SUBJECT: ISSUANCE OF EXIGENT AMENDMENT NOS. 165 AND 169 TO FACILITY
OPERATING LICENSE NOS. DPR-24 AND DPR-27 - POINT BEACH NUCLEAR
PLANT, UNIT NOS. 1 AND 2 (TACS M93619 AND M93620)

SUBJECT: ISSUANCE OF EXIGENT AMENDMENT NOS. 165 AND 169 TO FACILITY
OPERATING LICENSE NOS. DPR-24 AND DPR-27 - POINT BEACH NUCLEAR
PLANT, UNIT NOS. 1 AND 2 (TACS M93619 AND M93620)

ATTACHMENT TO LICENSE AMENDMENT NOS. 165 AND 169
TO FACILITY OPERATING LICENSE NOS. DPR-24 AND DPR-27
DOCKET NOS. 50-266 AND 50-301

SAFETY EVALUATION BY THE OFFICE OF NUCLEAR REACTOR REGULATION

Figure 15.2.1-2
REACTOR CORE SAFETY LIMITS
POINT BEACH UNIT 2

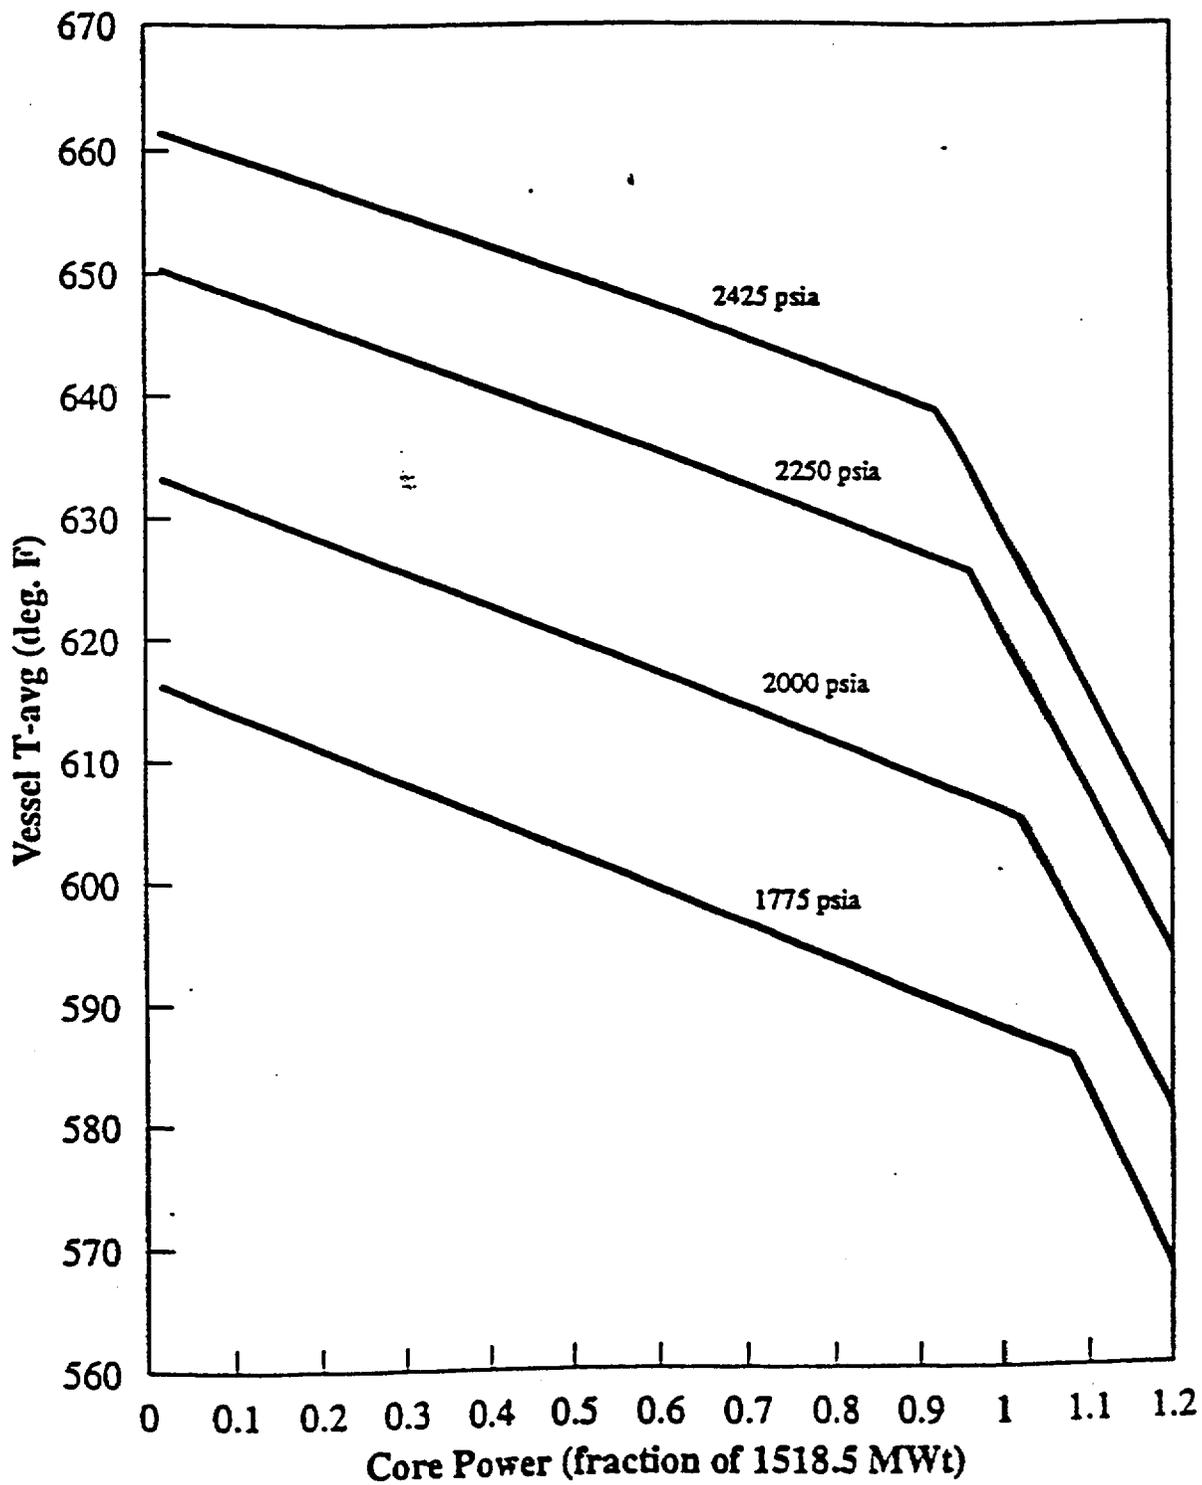
These amendments revise Technical Specification (TS) Section 15.1, "Definitions," TS Section 15.3.1.G, "Operational Limitations," and TS Figure 15.2.1-2, "Reactor Core Safety Limits, Point Beach Unit 2." The changes reduce the reactor coolant system raw measured total flow rate limit and reflect new reactor core safety limits for Unit 2. The basis for TS Section 15.3.1.G is also changed.

The result of the proposed reduced flow on the non-LOCA transient analysis is that the thermal safety limits become more limiting at all power and pressure levels. Based on this, the licensee submitted a revised Unit 2 TS Figure 15.2.1-2, Reactor Core Safety Limits.

The proposed reduced flow rate causes a penalty to the departure from nucleate boiling ratio (DNBR). The current Revised Thermal Design Procedure DNBR limit of 1.33 remains valid for the reduced flow conditions. The licensee indicated that they analyzed the most DNB-limiting non-LOCA accidents and determined that the current limit remains valid for the proposed reduced flow.

The licensee obtained unacceptable results for the underfrequency event at 100% power, 1518.5 megawatts thermal (Mwt). The licensee indicated that they did a complete and separate analysis of the underfrequency event with the proposed flow reduction at 98% of rated power and obtained acceptable results. Therefore, the licensee is proposing the TS limitation that Unit 2 operation be limited to 98% of the rated power when the RCS raw measured flow is less than 174,000 gpm but greater than 169,500 gpm.

Based on the reanalyses, the licensee determined that the conclusions of PBNP Final Safety Analysis Report (FSAR) Chapter 14, with respect to the DNB acceptance criterion for non-LOCA accidents, remain valid for a reduction of the raw measured flow below 174,000 gpm down to 169,500 gpm, provided the rated power remains at or below 98% of 1518.5 Mwt. The non-LOCA transients with non-DNB acceptance criteria were also reanalyzed and found to meet the acceptance criteria with the reduced flow. The staff agrees with the licensee's proposal to limit Unit 2 to 98% of rated power while the RCS flow is reduced.
